177-17-CA
 1104 W LENOIR STREET

Nature of Project: Construct house and garage; install walkways and driveways.

STAFF REPORT

1102 and 1104 W Lenoir Additional supporting evidence as requested by CoA Committee

614 Chamberlain Street Real cedar shingles

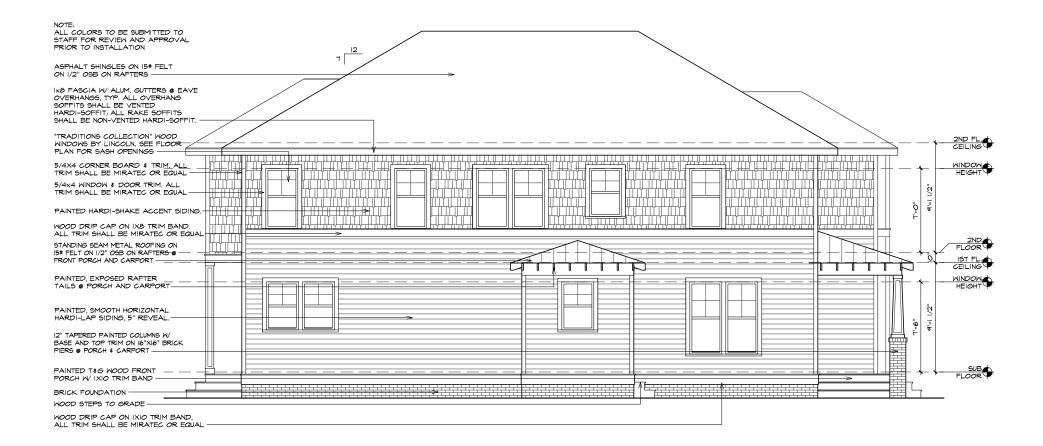
- 14* The applicant provided an example of existing houses that feature cedar shingles (614 Chamberlain St) and fiber cement shingles (612 Chamberlain St). Painted and unpainted samples will be brought to the meeting.

- 5) Provide address of a built house that has synthetic (Hardi) shingle siding.
 - a. See attached sheet for adjacent houses at 612 and 614 Chamberlain Street for both real and synthetic cedar shingles.

Samples of painted real cedar shingles and painted Hardi-shingles shall be brought to the hearing for comparison.

COA APPLICATION FOR 1104	W. Lenoir S	treet
RIGHT ELEVATION	SCALE: 1/8" = 1'-0"	DATE: 01/08/2017

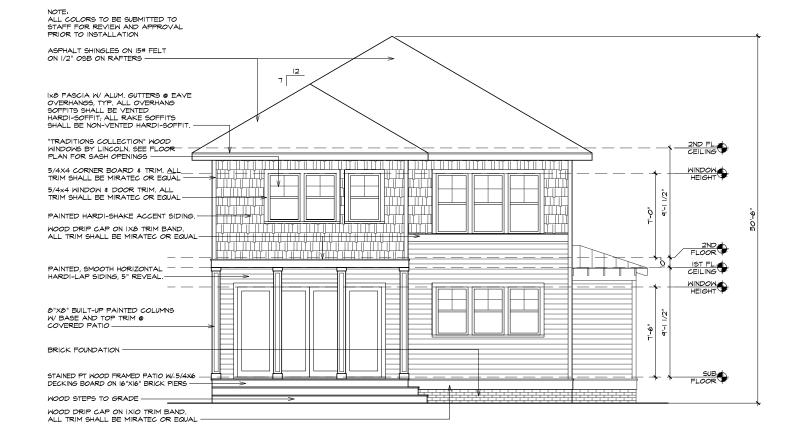
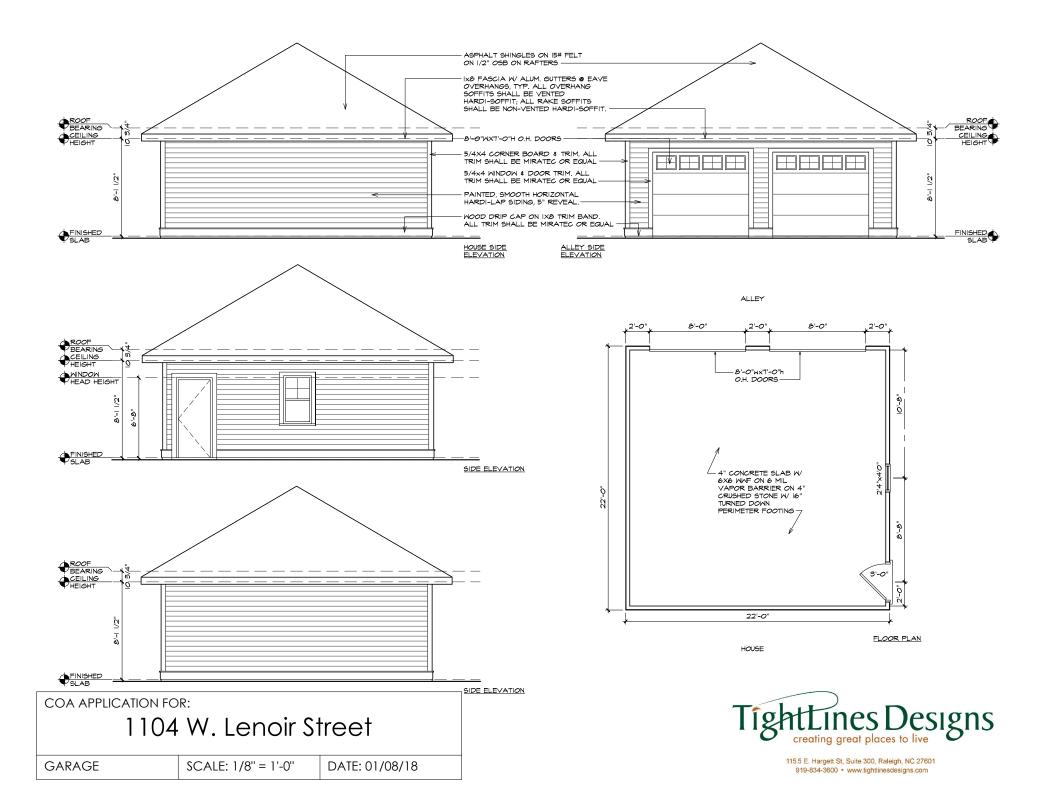
12* Amended drawings show a lowering of the roof height by changing the roof pitch to 7/12.

Design change: Based on the concern expressed by the Committee and the public at the hearing, the heights of the houses have been reduced by lowering the roof pitch and lowering the roof bearing condition. See attached revised exterior elevations.

COA APPLICATION FO	^{R:} W. Lenoir S ⁻	treet
SITE SECTION	SCALE: 1/16" = 1'-0"	DATE: 01/08/2018

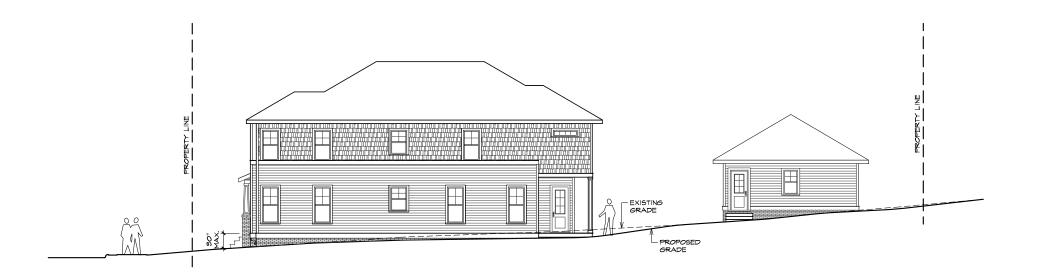
- 3* A site section that shows the rise in grade from the street to the rear alley was provided. It shows regrading in the area between the garage and the rear of the house.

THREE EXISTING HOUSES ON SAME BLOCK ARE TALLER THAN PROPOSED HOUSE DESIGNS.

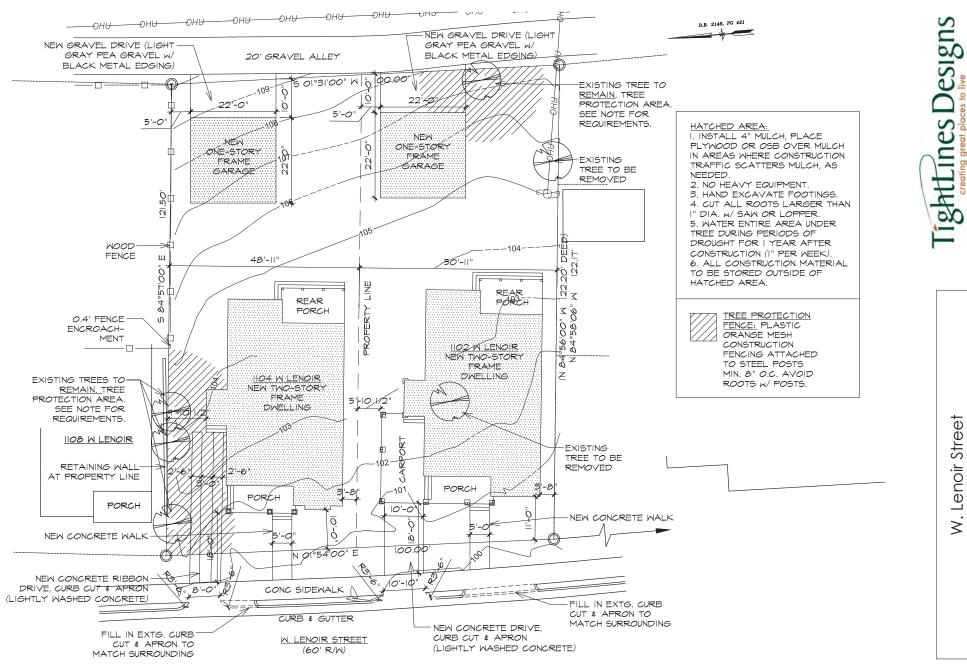
- 8* The applicant provided illustrations of three other two-story houses on the same block that are taller than the proposed house, all of which are behind the houses across the alley:

- 2) Provide actual heights of proposed houses as compared to proposed two story houses on same block. See attached for supporting photos and diagrams. Facts:
 - a. Proposed houses are 30.5' high to the ridge.
 - b. 422 Cutler Street is 34' tall.
 - c. 420 Cutler Street is 31' tall.
 - d. 418 Cutler Street is 32.5' tall.

Summary: all three existing houses at 422, 420, and 418 Cutler Street are taller than the proposed houses; therefore the height of the proposed houses is not incongruous.
